DUKE POWER COMPANY

OCONEE NUCLEAR STATION, UNIT 1

AMENDMENT TO FACILITY OPERATING LICENSE

ATTACHMENT TO LICENSE AMENDMENTS

CONTROL ROD GROUP WITHDRAWAL LIMITS FOR 4 PUMP OPERATION UNIT 2

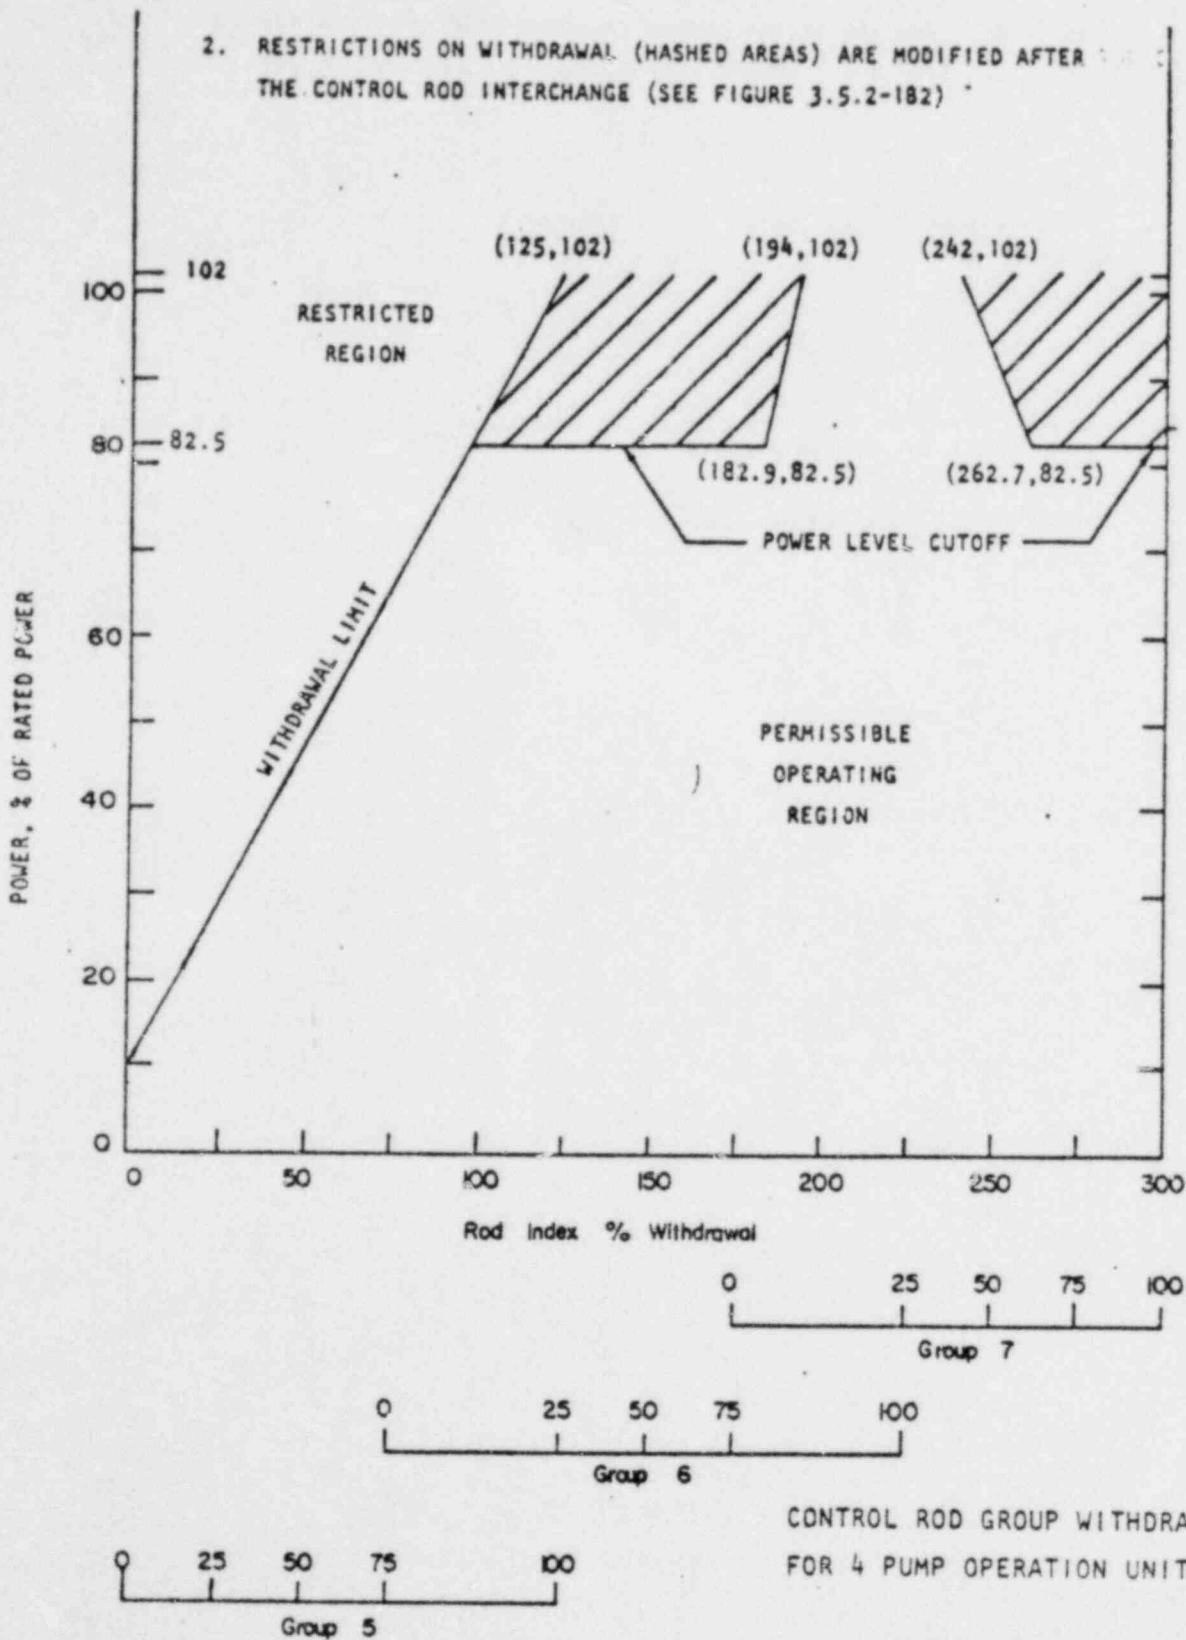
2. RESTRICTIONS ON WITHDRAWAL (HASHED AREAS) ARE MODIFIED AFTER THE CONTROL ROD INTERCHANGE (SEE FIGURE 3.5.2-182)

UNIT 2
OCONEE NUCLEAR STATION
Figure 3.5.2-182

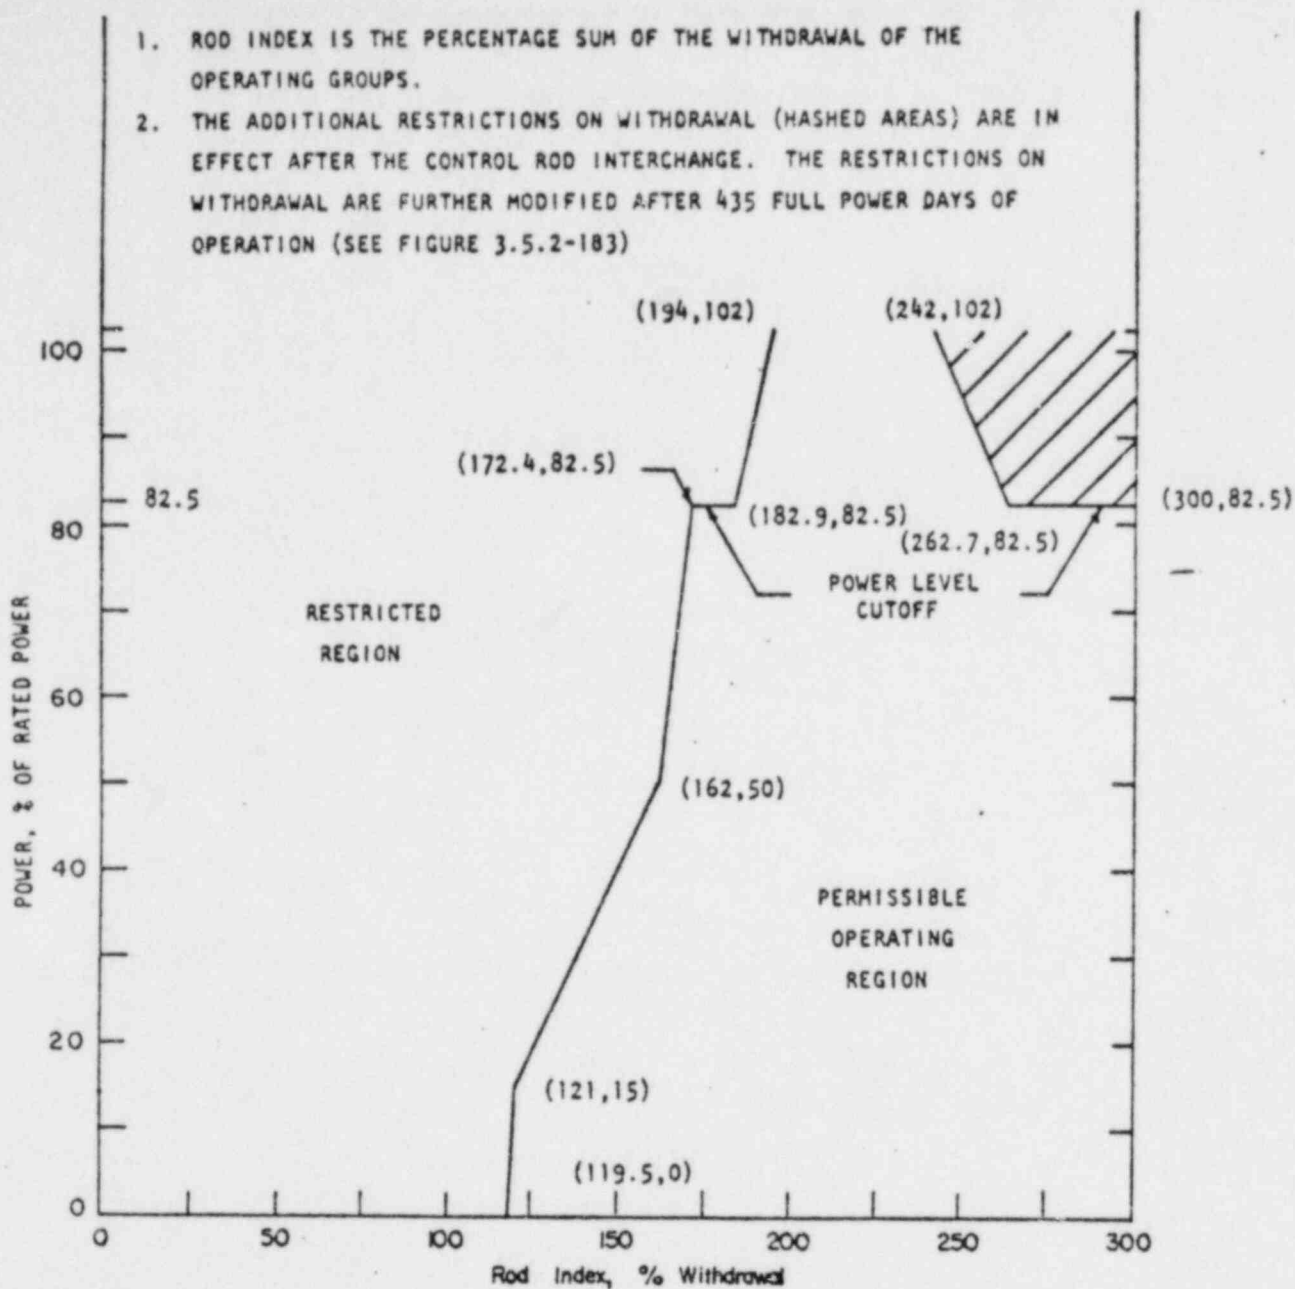
1. ROD INDEX IS THE PERCENTAGE SUM OF THE WITHDRAWAL OF THE OPERATING GROUPS.
2. THE ADDITIONAL RESTRICTIONS ON WITHDRAWAL (HASHED AREAS) ARE IN EFFECT AFTER THE CONTROL ROD INTERCHANGE. THE RESTRICTIONS ON WITHDRAWAL ARE FURTHER MODIFIED AFTER 435 FULL POWER DAYS OF OPERATION (SEE FIGURE 3.5.2-183)

UNIT 2
 OCONEE NUCLEAR STATION
 Figure 3.5.2-1B3

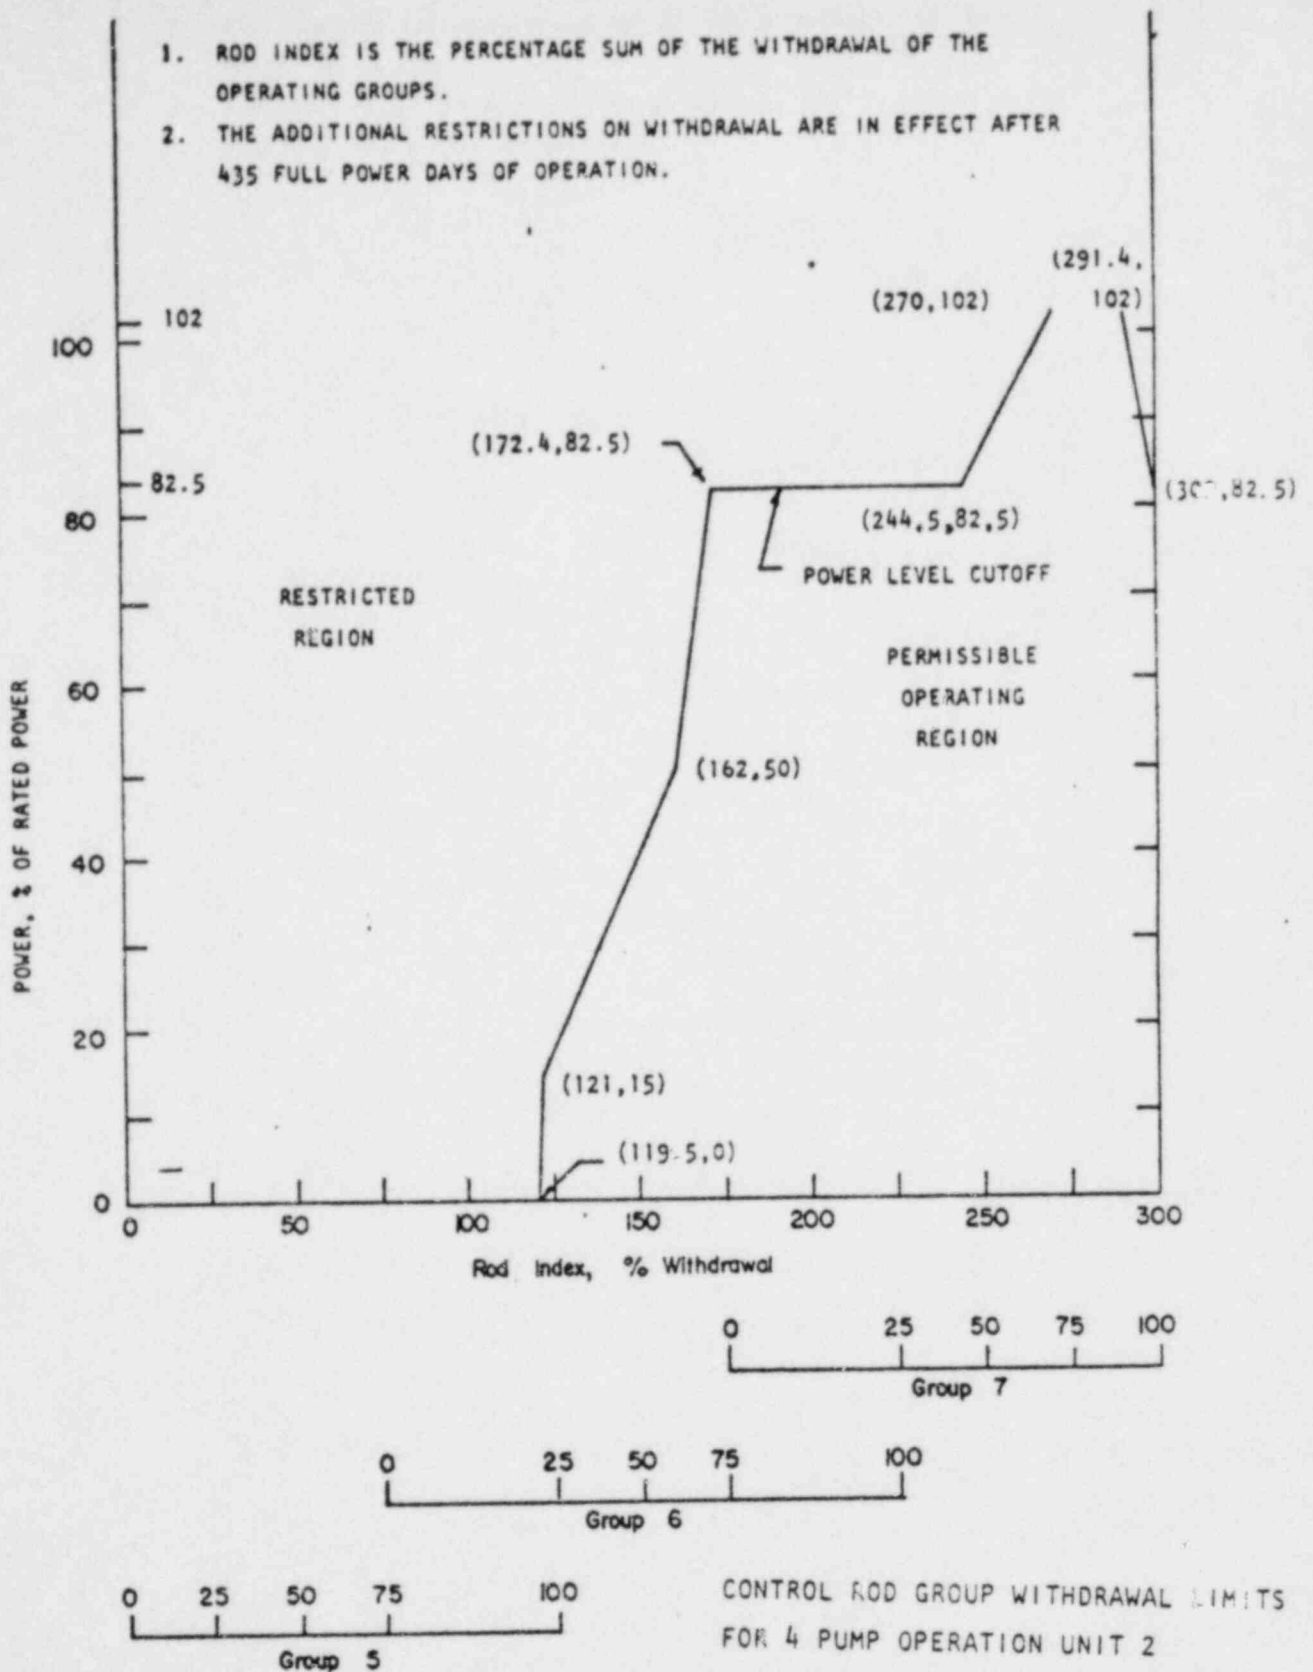
1. ROD INDEX IS THE PERCENTAGE SUM OF THE WITHDRAWAL OF THE OPERATING GROUPS.
2. THE ADDITIONAL RESTRICTIONS ON WITHDRAWAL ARE IN EFFECT AFTER 435 FULL POWER DAYS OF OPERATION.

UNIT 3
OCONEE NUCLEAR STATION
Figure 3.5.2-1C1

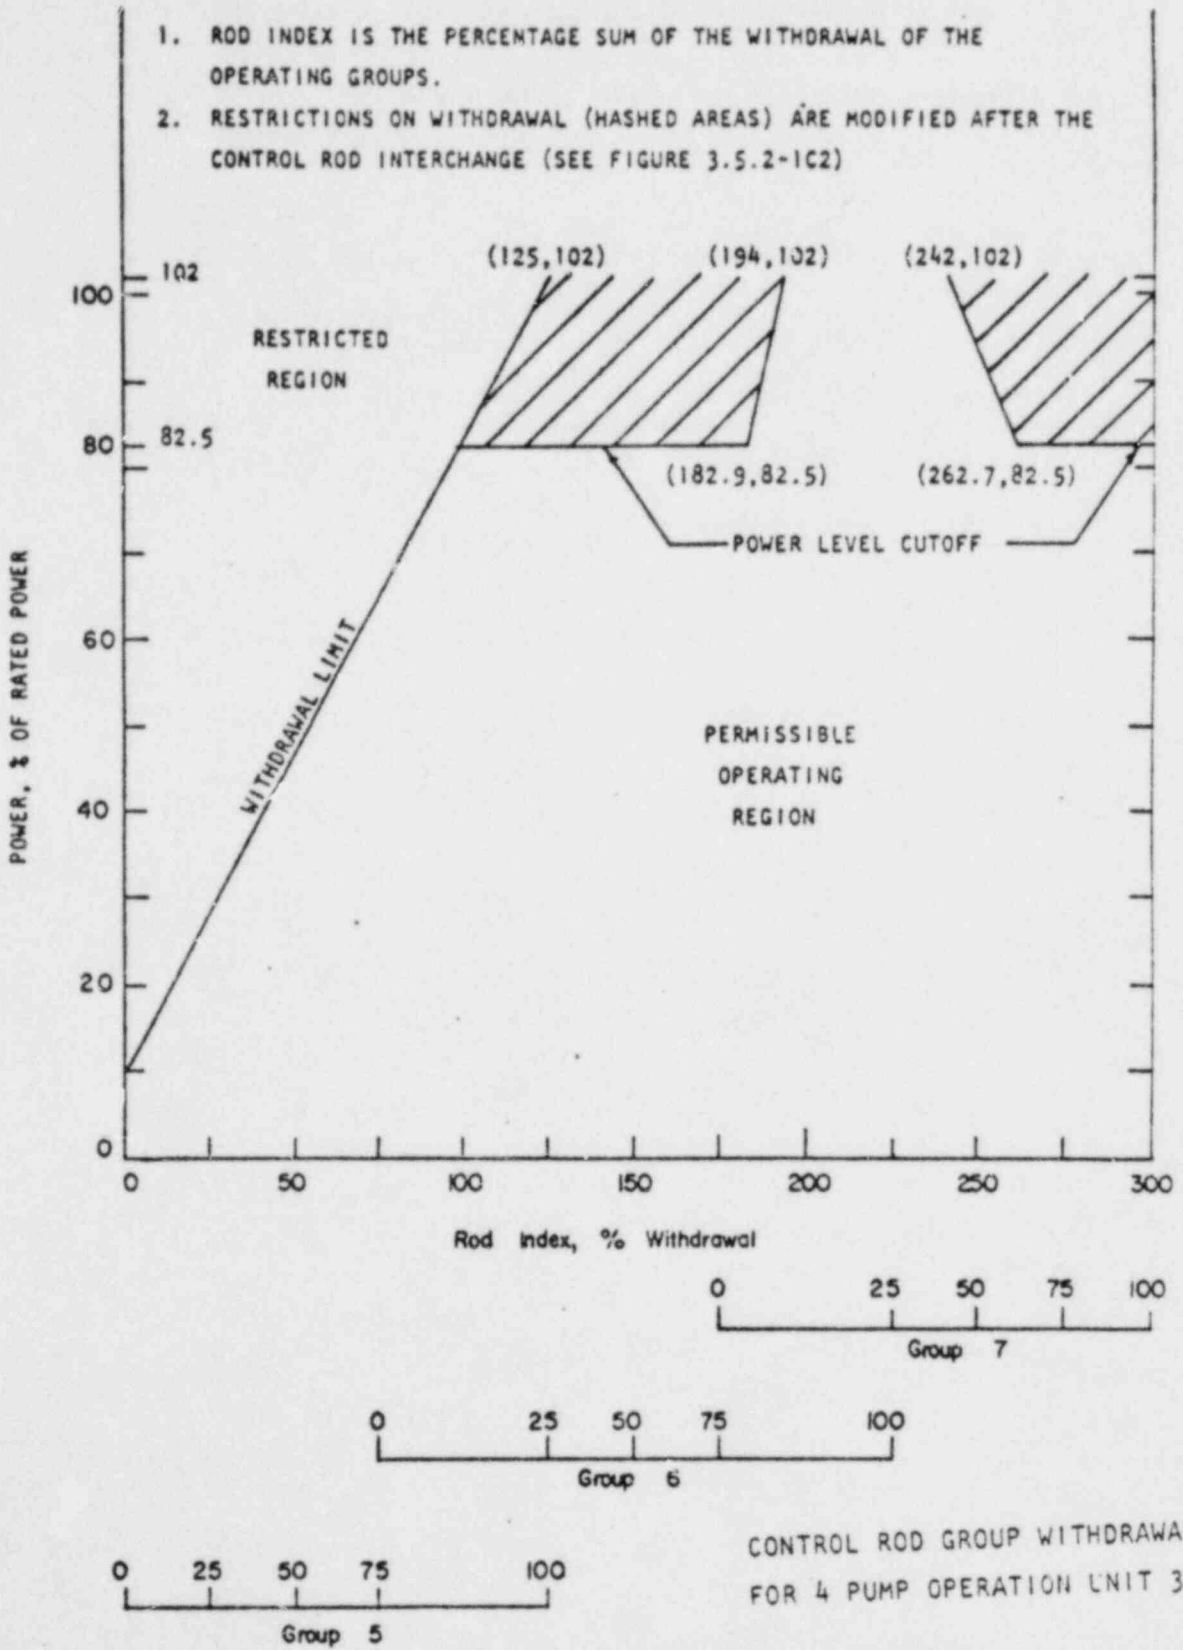
1. ROD INDEX IS THE PERCENTAGE SUM OF THE WITHDRAWAL OF THE OPERATING GROUPS.
2. RESTRICTIONS ON WITHDRAWAL (HASHED AREAS) ARE MODIFIED AFTER THE CONTROL ROD INTERCHANGE (SEE FIGURE 3.5.2-1C2)

UNIT 3
OCONEE NUCLEAR STATION
Figure 3.5.2-1C2

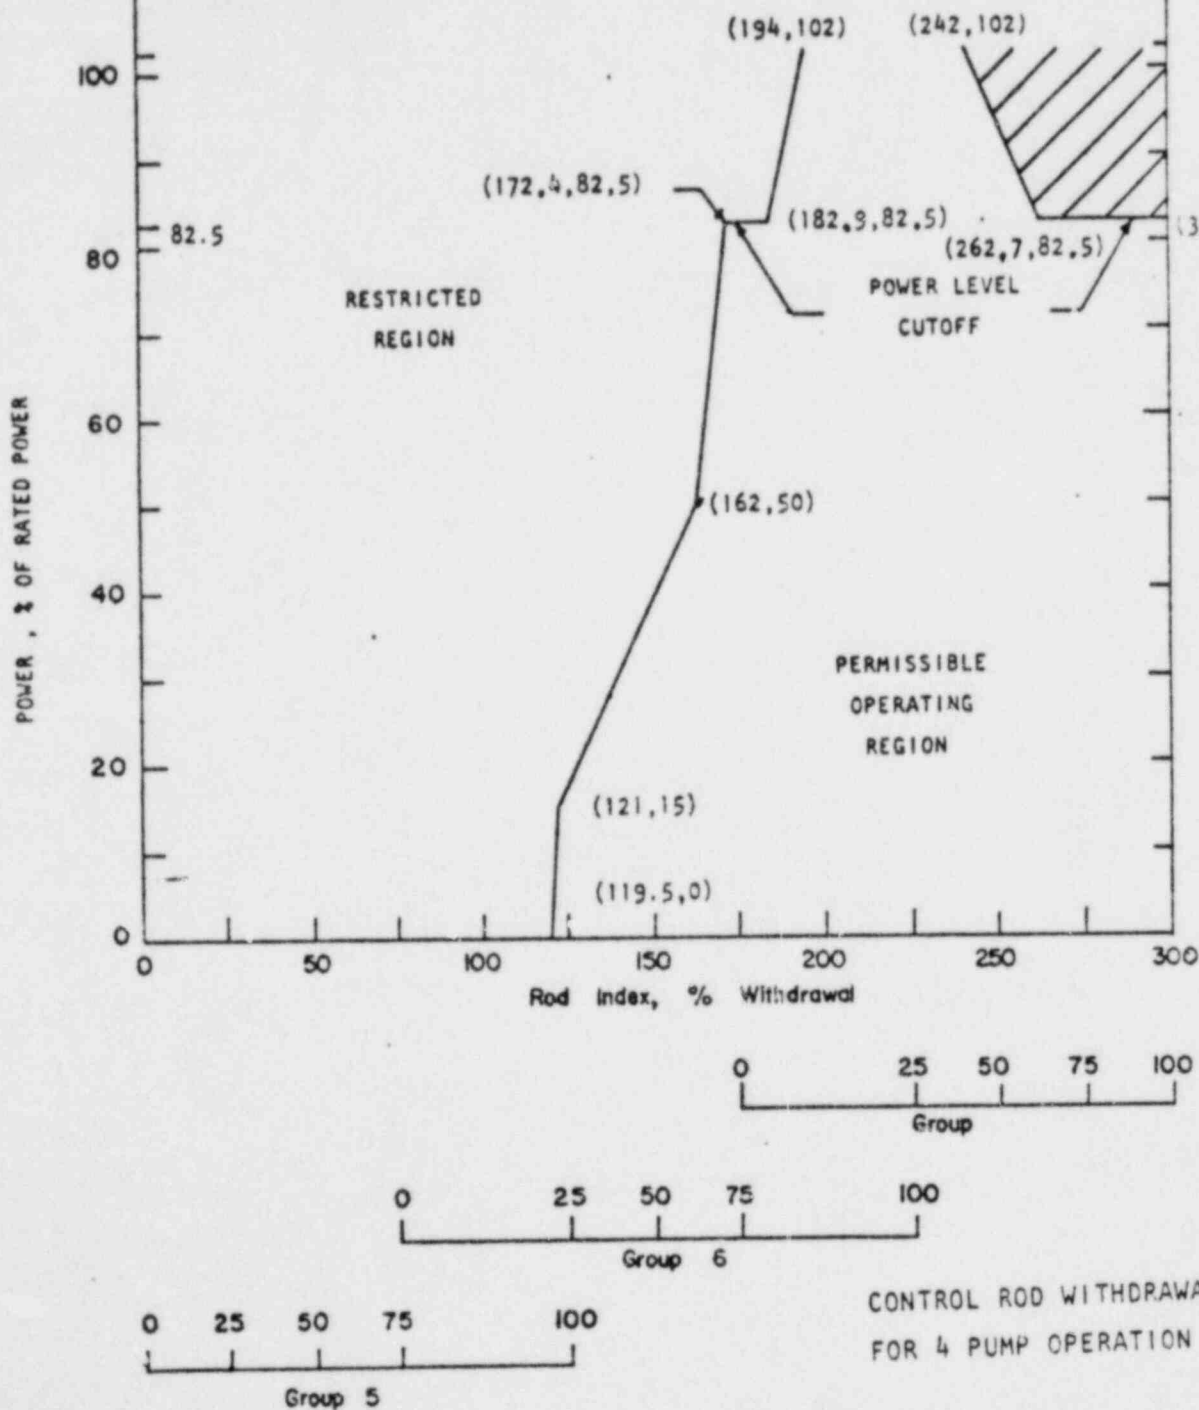
1. ROD INDEX IS THE PERCENTAGE SUM OF THE WITHDRAWAL OF THE OPERATING GROUPS.
2. THE ADDITIONAL RESTRICTIONS ON WITHDRAWAL (HASHED AREAS) ARE IN EFFECT AFTER THE CONTROL ROD INTERCHANGE. THE RESTRICTIONS ON WITHDRAWAL ARE FURTHER MODIFIED AFTER 435 FULL POWER DAYS OF OPERATION (SEE FIGURE 3.5.2-1C3)
